1977 Corvette: Service Bulletin: Anti-Theft Alarm System Interim Modifications

Subject: Anti-Theft Alarm System Interim Modifications

Model and Year: 1977 Corvette

Bulletin No: 77-I-38

FIGURE 1

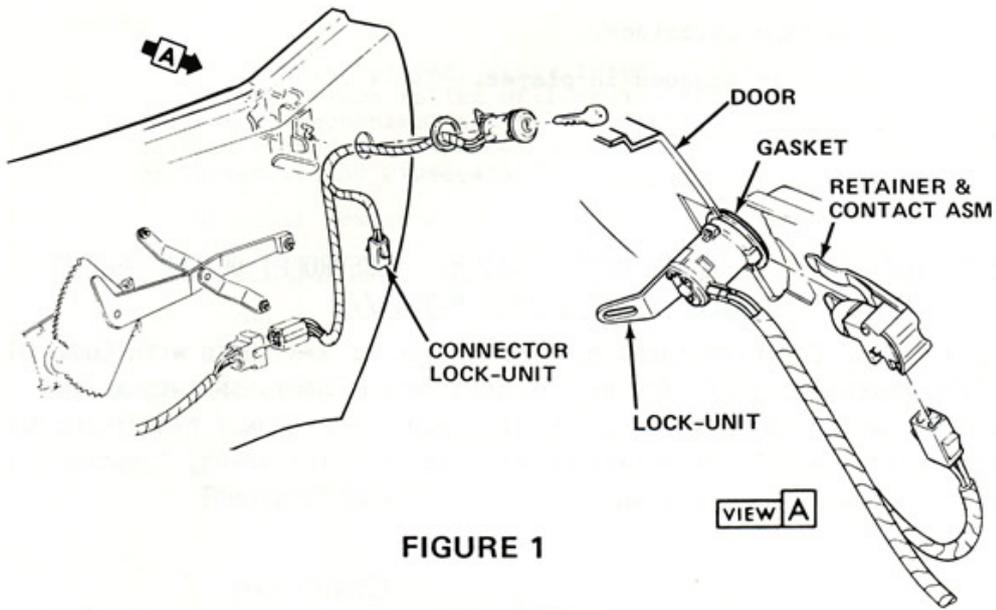
- The actuating switch for the system is no longer located on the left front fender. It has been incorporated into the left front door lock and must be activated by locking this door with the key from outside of the vehicle (Figure 1). This is the only way the alarm can be set. Turning the inside door knob to the locked position when exiting the vehicle will not activate the alarm system.
- The anti-theft alarm system horn has been moved from the left rear inner fender to the far left side of the engine compartment dash panel. (Figure 2).
- The anti-theft alarm system flasher assembly is now located on the console trim plate (Figure 3), rather than the rear compartment underbody panel.
- The new anti-theft alarm system wiring diagram is illustrated in Figure 4.
